## Department of Planning and Zoning

**TO:** Development Review Board  
**FROM:** Scott Gustin  
**DATE:** December 17, 2013  
**RE:** 14-0571SP; 121-123 Pine Street

**Request:** Sketch plan review for proposed four story apartment building with underground parking.

SHEET TITLE:  
PARKING GARAGE  
PLAN

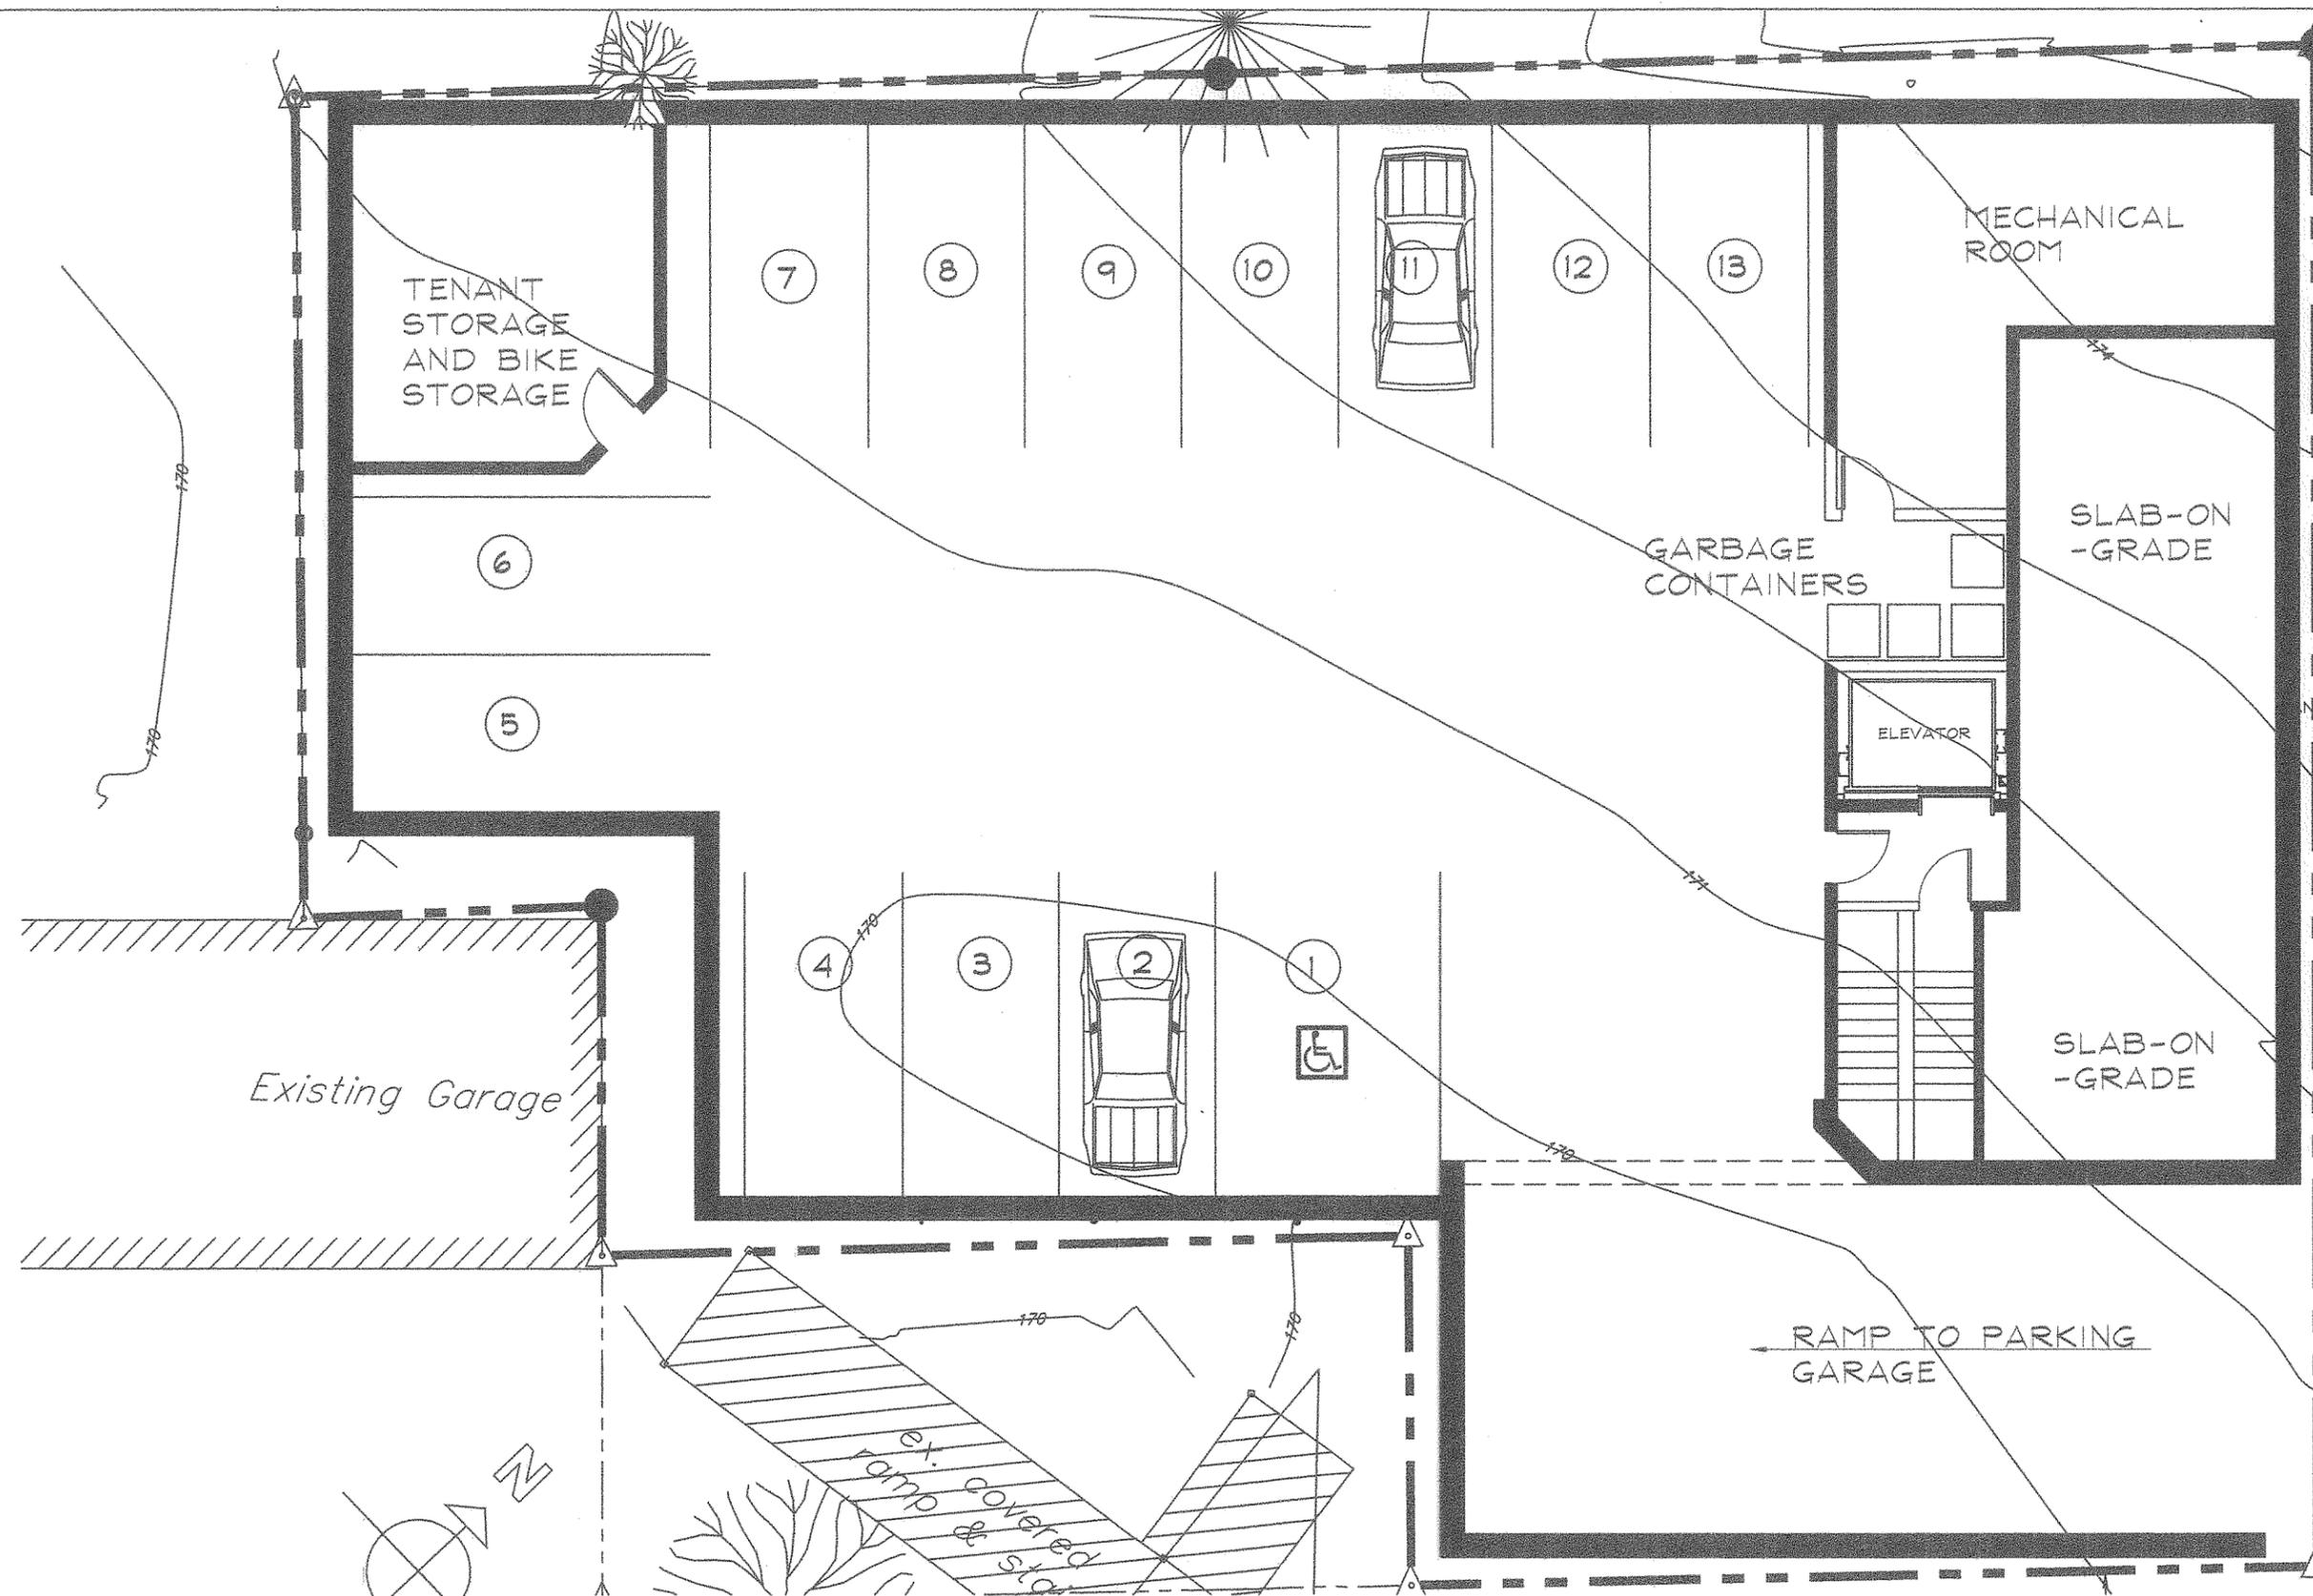
A mechanical room and space for garbage containers are located within the underground garage. Access to the trash containers by waste haulers needs to be considered.

Bicycle parking will be required as acknowledged by the application; however, detail has not yet been provided beyond a "bike storage" notation in the garage plan.

SHEET TITLE:  
NEW FIRST FLOOR  
PLAN

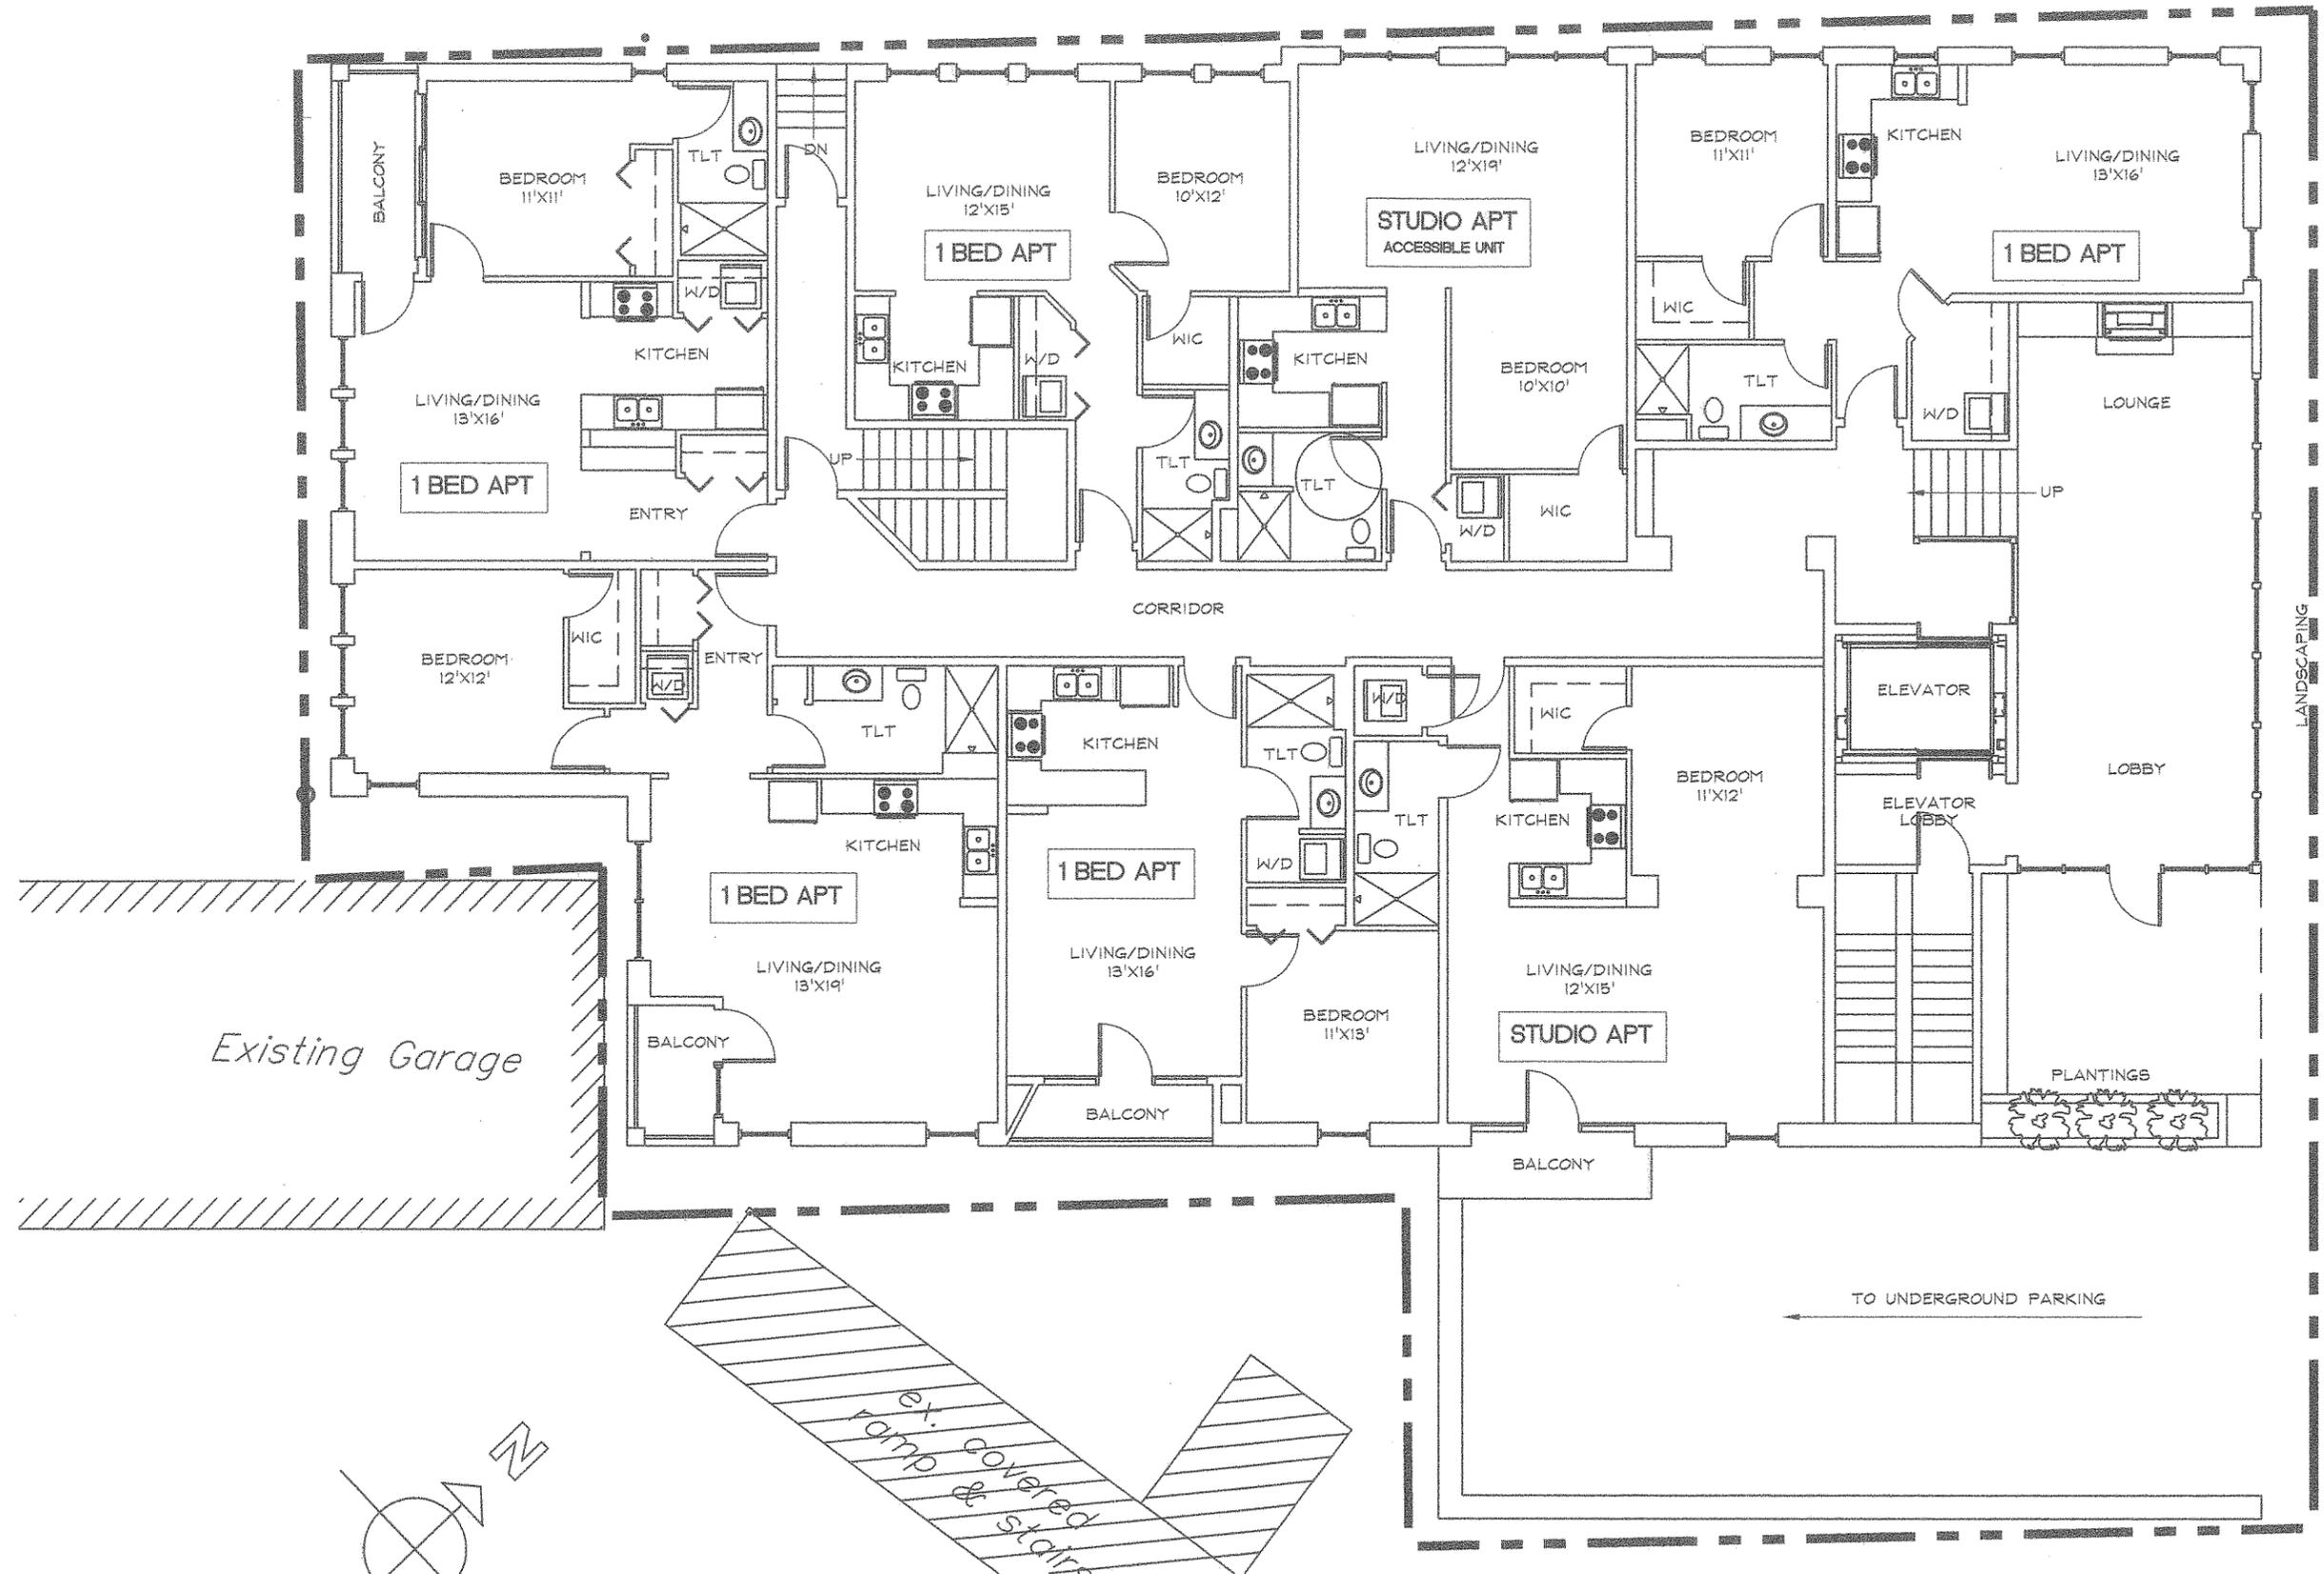
As this proposal is for a new building, residential uses on the ground floor are not allowed. As proposed, the street frontage of the building contains a lobby. While not a residence, the lobby is part and parcel of the residential use of the building. It is not a distinct, separate use. More problematic, however, are the residential dwelling units located behind the lobby on the first floor. While sketch plan details are limited, these units, while above underground parking, appear to be at ground level and are not permitted.
